ADDENDUM NO: 01

PROJECT: Pendleton Elementary Roofing Replacement

PROJECT NO: 2026060

DATE: 07/24/26

CERTIFIED BY:

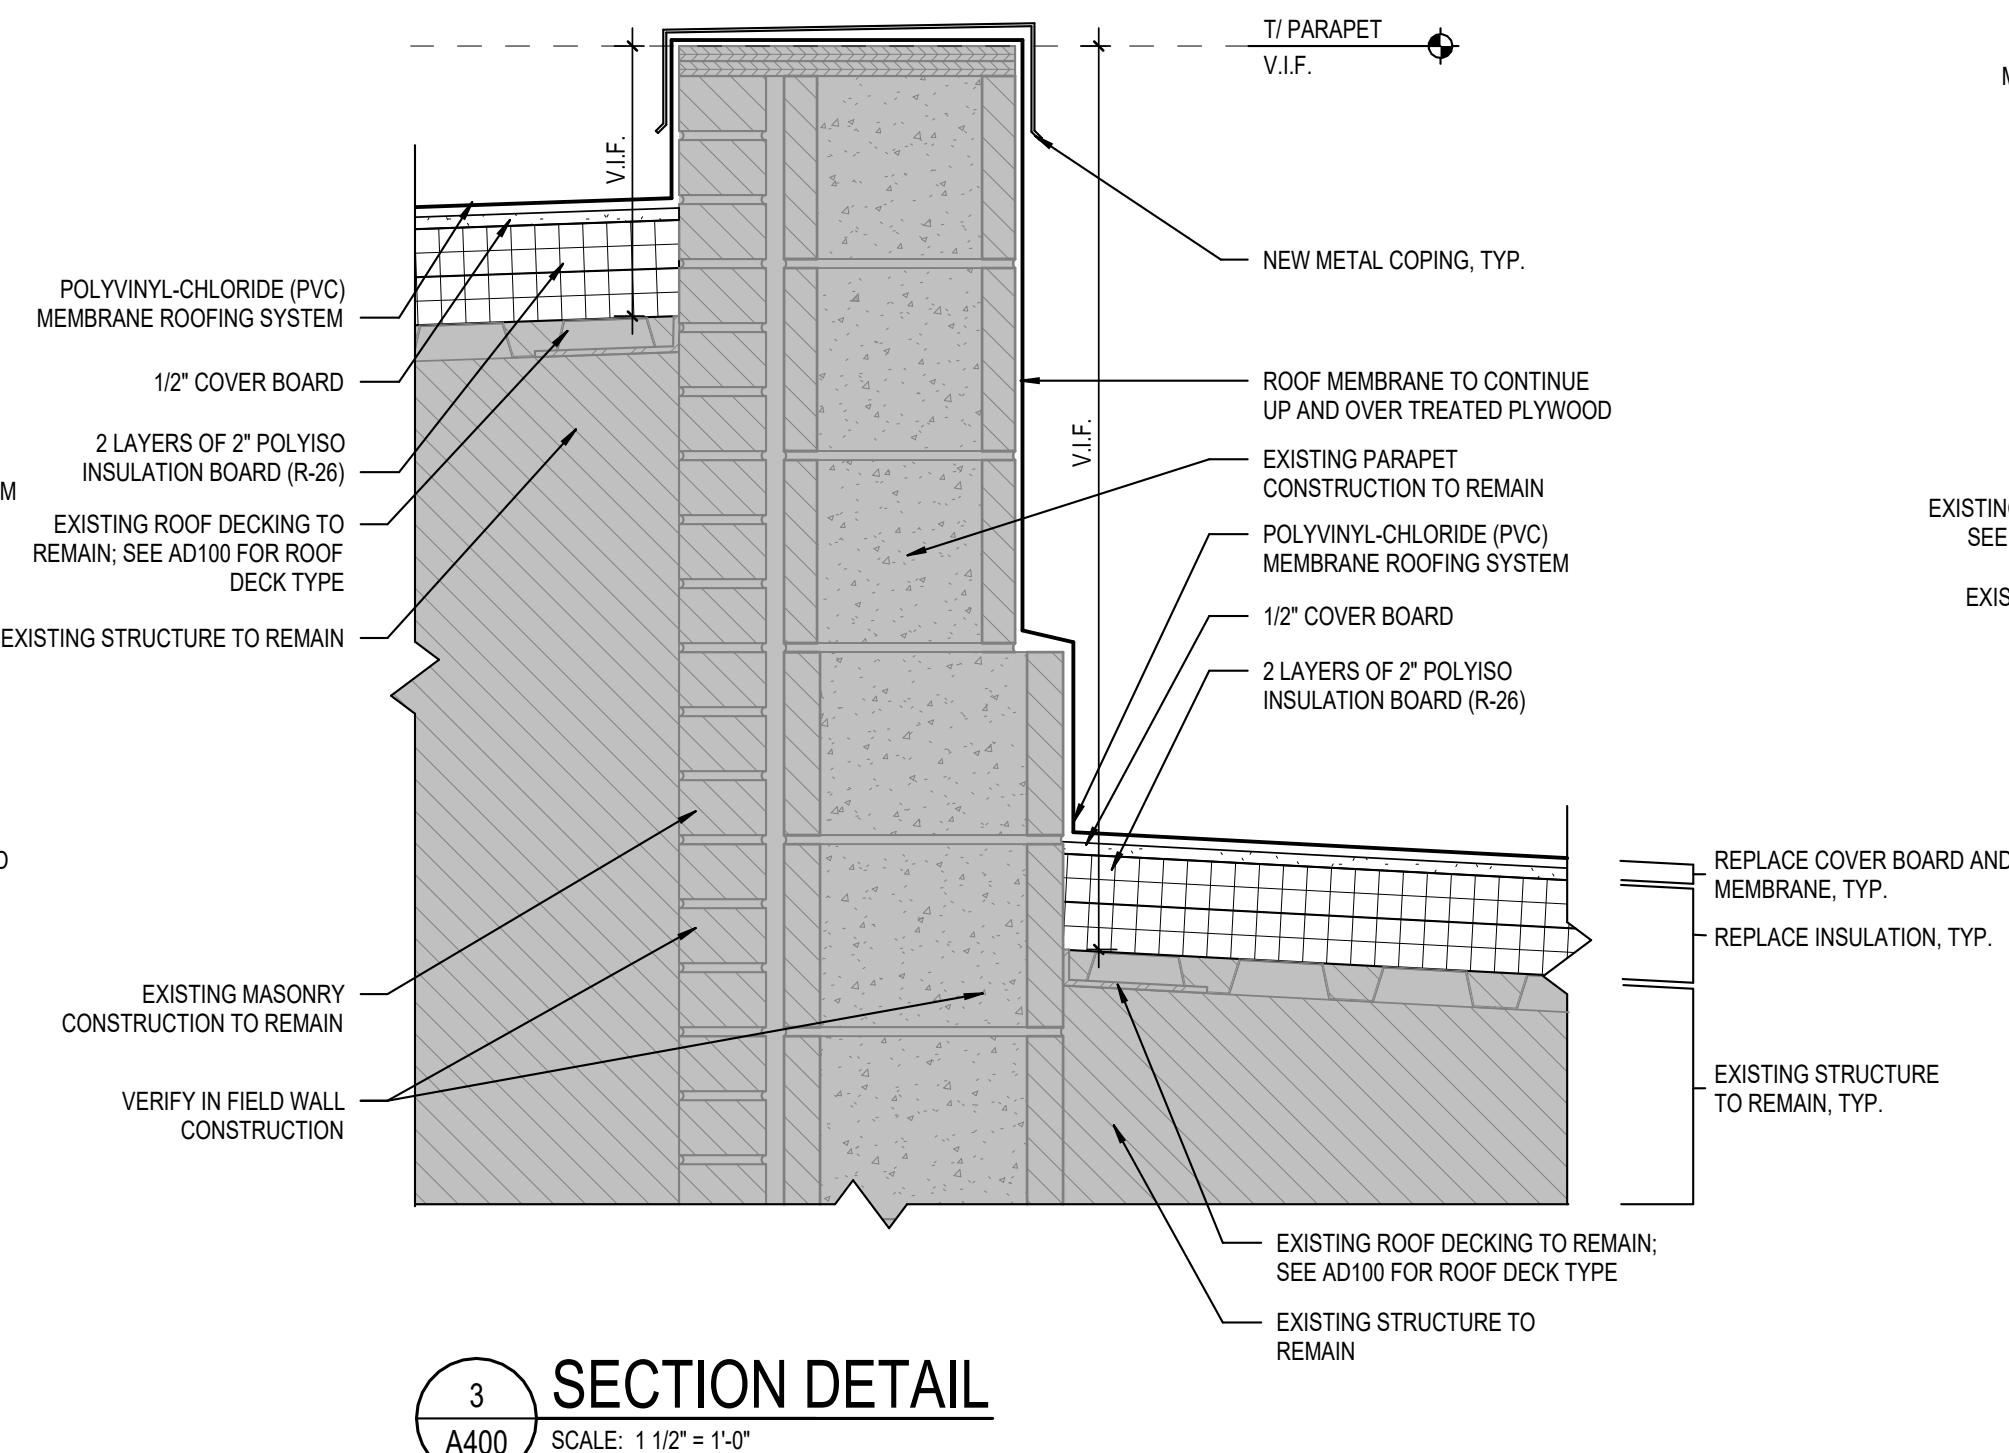
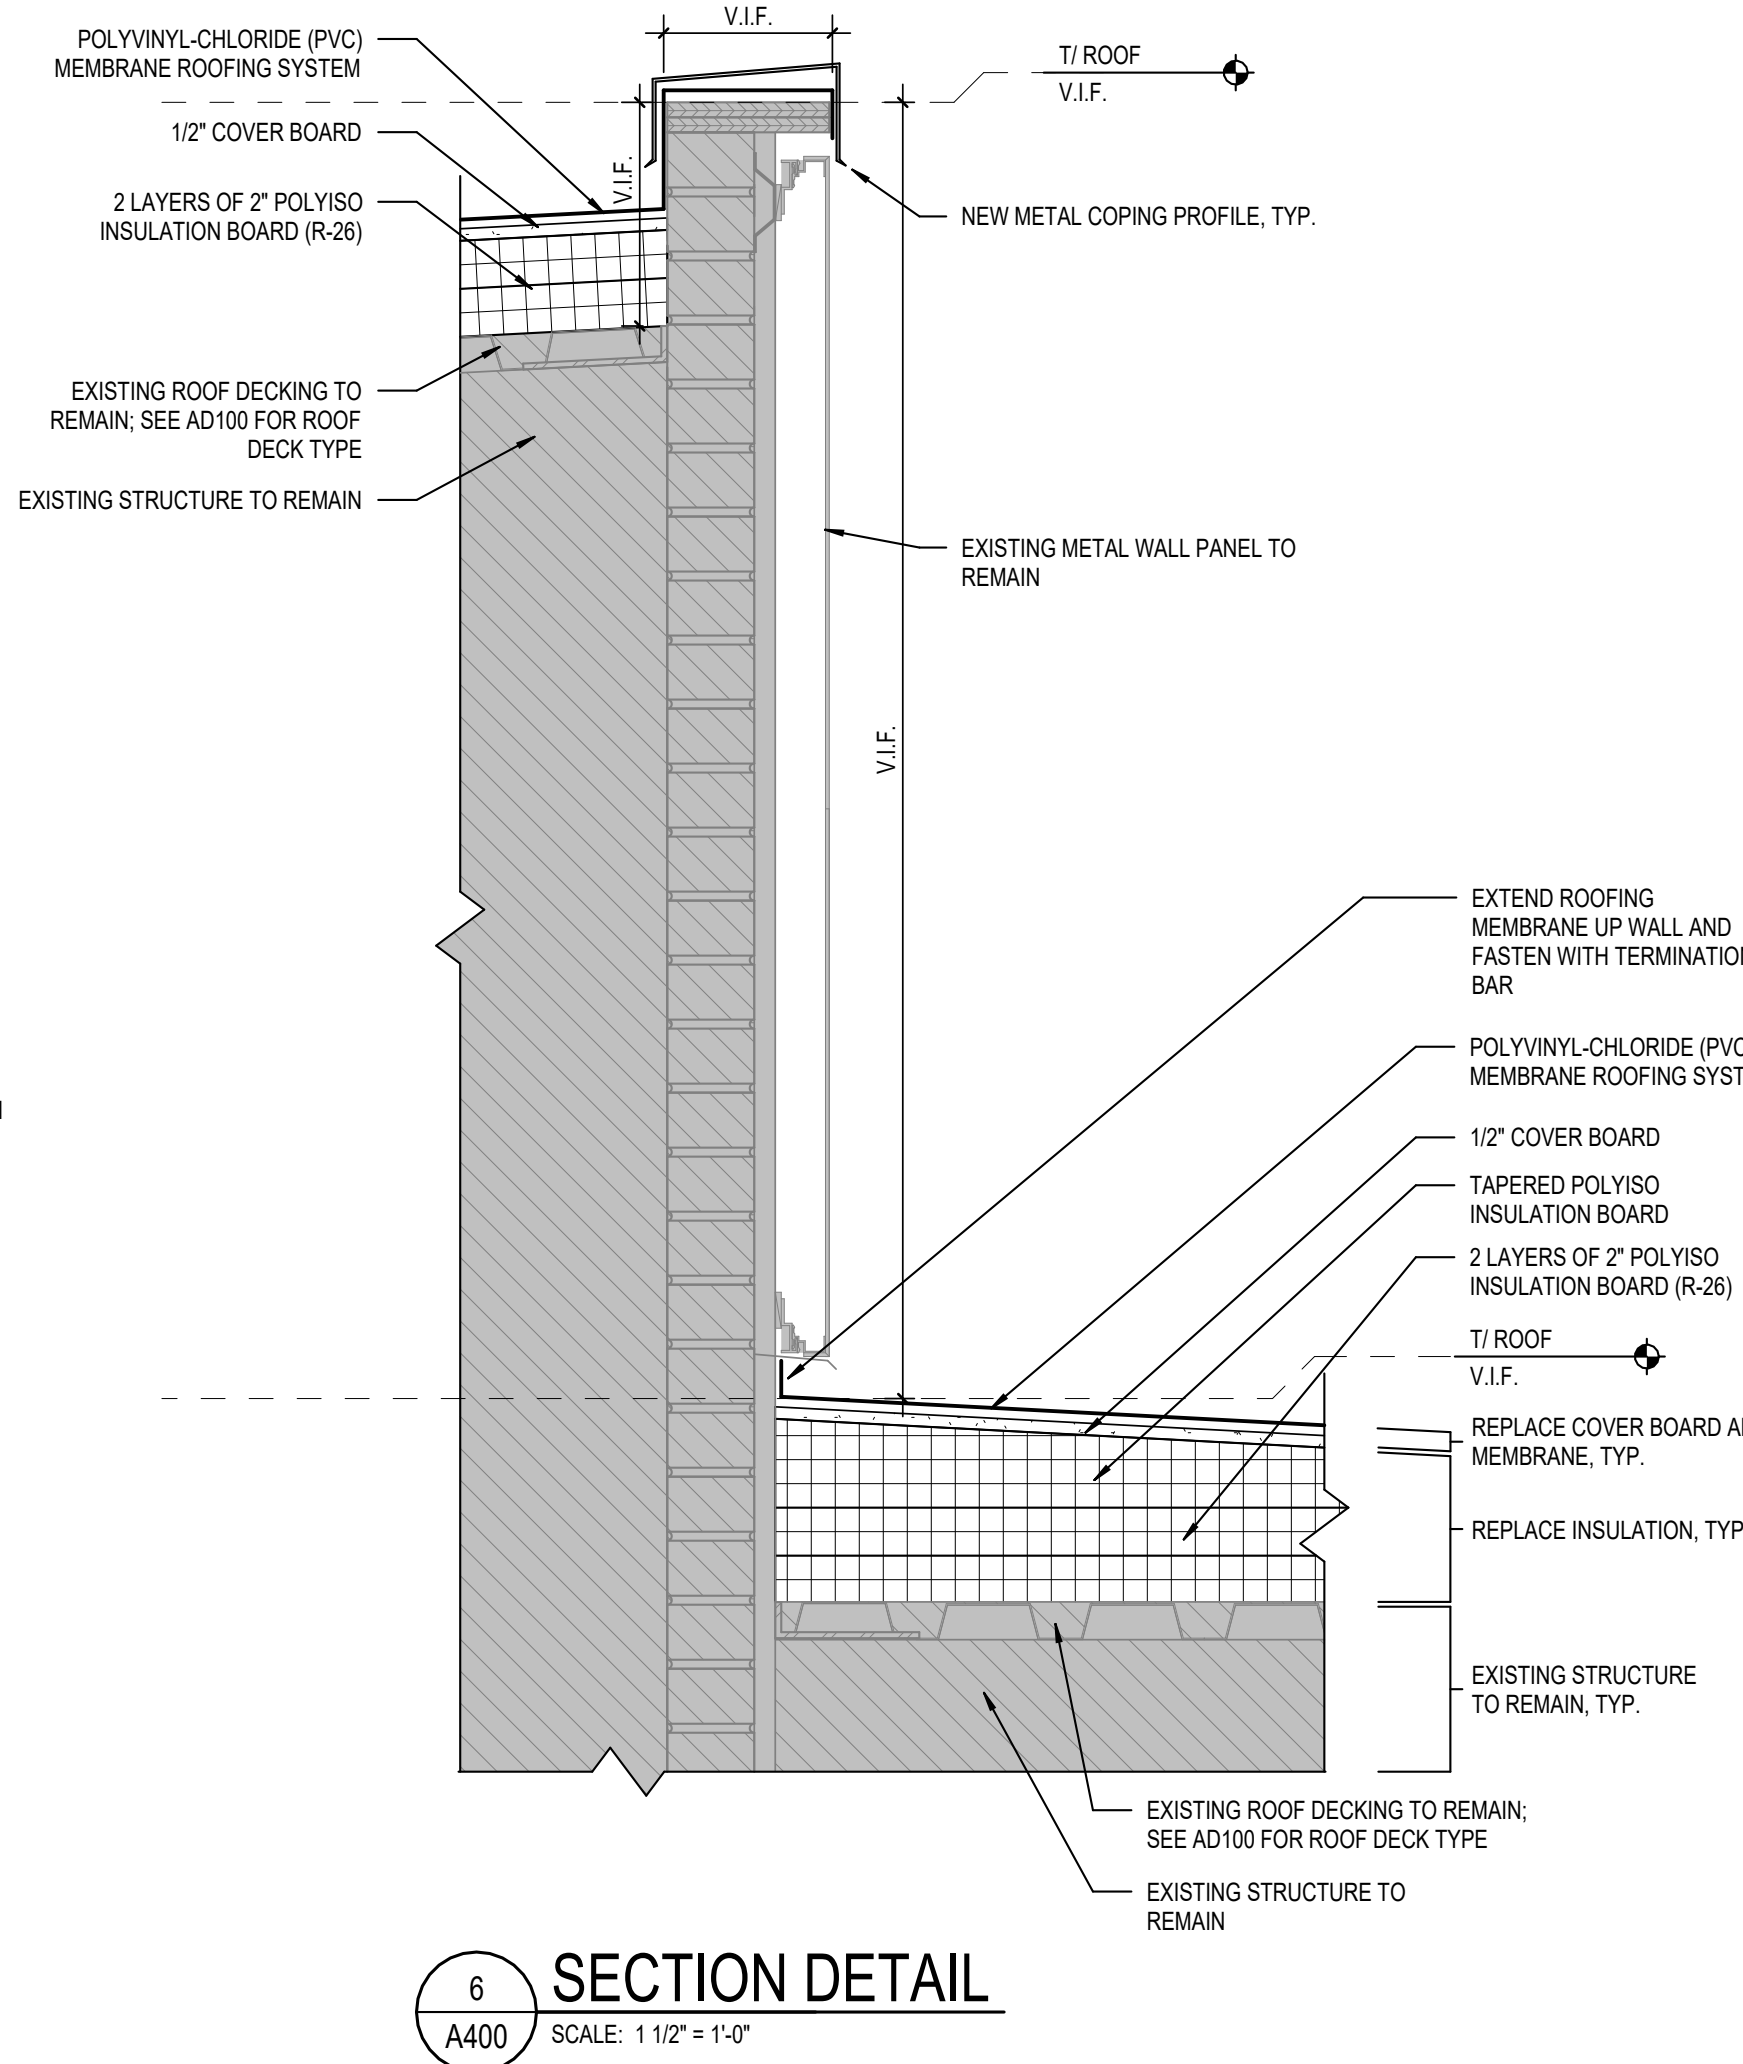
3.3 A400 – SECTION DETAILS

A. Revise all details to depict existing roof conditions.
